BOARD ACTION REPORT – APPEALABLE ITEM

Project Name: Park at Delray
Project Location: Southwest corner of Congress Avenue and Germantown road
Request: Class V Site Plan
Board: Site Plan Review and Appearance Board
Meeting Date: November 18, 2020

SITE PLAN REVIEW AND APPEARANCE BOARD MEMORANDUM File No.: 2020-096-233-SPF-SPR-CL5 Application Type: Class 5 Site Plan – Parks at Delray Meeting: November 18, 2020 **General Data:** Agent: Covelli Design Associates, Inc Applicant/Owner: Centerpointe Delray Holdings, LLLP Location: Southwest corner of Congress Avenue and Germantown Road (1690-2350 South Congress) PCN: 12-43-46-30-37-000-0010 12-43-46-30-15-001-0000 12-43-46-30-37-000-0020 12-43-46-30-39-001-0010 Property Size: 23.13 acres LUM: CMU (Commercial Mixed Use) Zoning: SAD (Special Activities District) **Adjacent Zoning:** • North: RM (Multiple Family Residential) South: RM & OSR (Open Space & Recreation) o East: MROC (Mixed Residential Office and Commercial) I (Industrial) o West: RM Existing Land Use: Former Office Depot campus and the Arbors office building Proposed Land Use: Multiple Family Residential - 600 total residential units FAR: 1.20 Item before the Board:

DRAWN DATE SCALE JOB NO. SHEET TITLE: 04/10/2020 AS SHOWN 1890.PRJ DUMPSTER ENCLOSURE SHEET NUMBER: TC-A-2.1

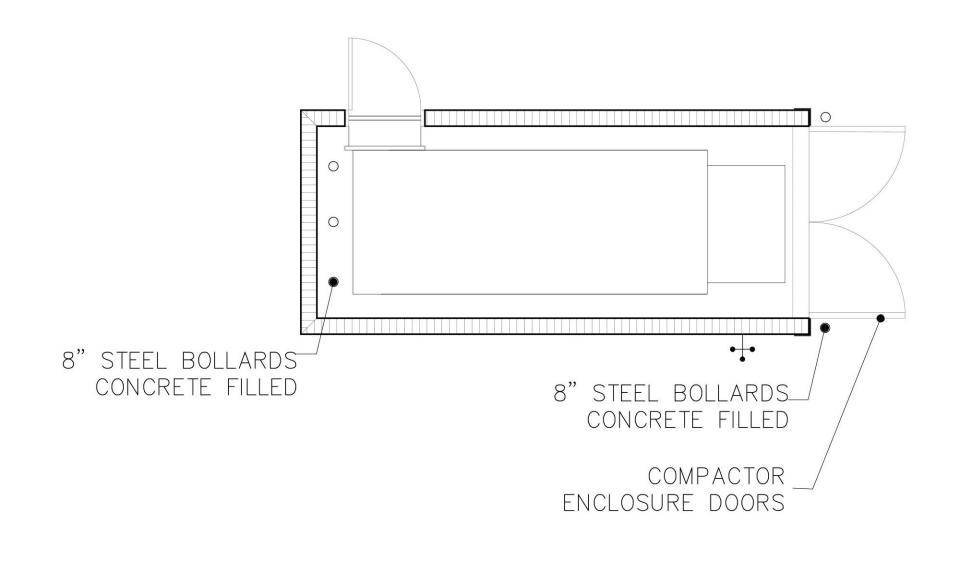
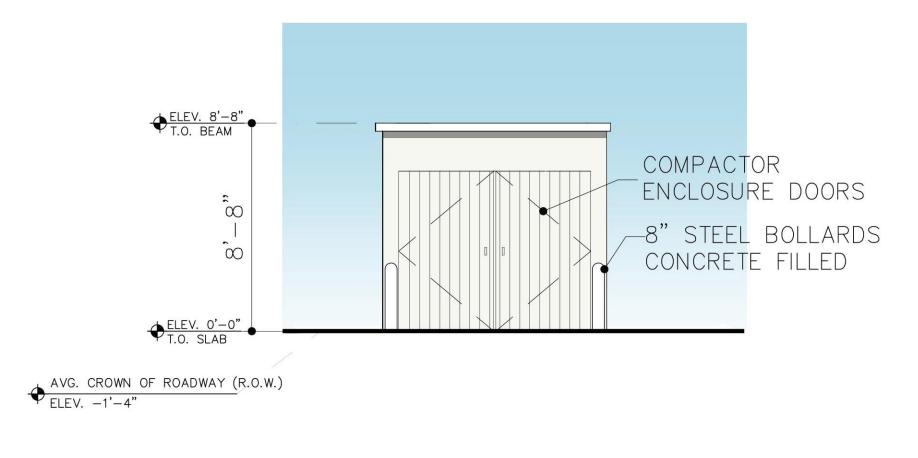
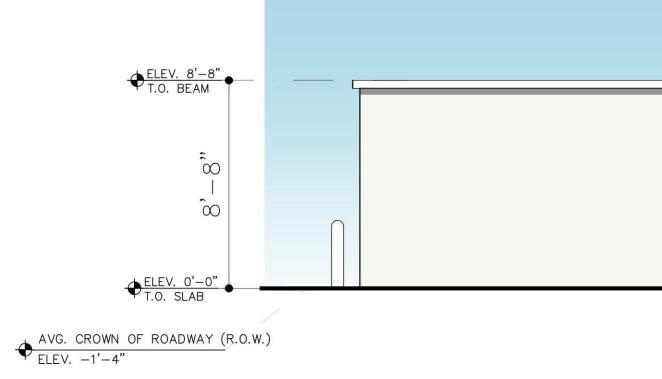
- 5. That the 6-foot wide sidewalks are provided for the infrastructure roadway prior to site plan certification.
- 6. That a dumpster enclosure detail be provided prior to site plan certification.

The plans indicate that the dumpster enclosures will be enclosed. However, a detail of the enclosures is not provided with the site plan. A note is attached to this staff report that an enclosure detail be provided prior to site plan certification. The ground level mechanical equipment is screened by landscaping.
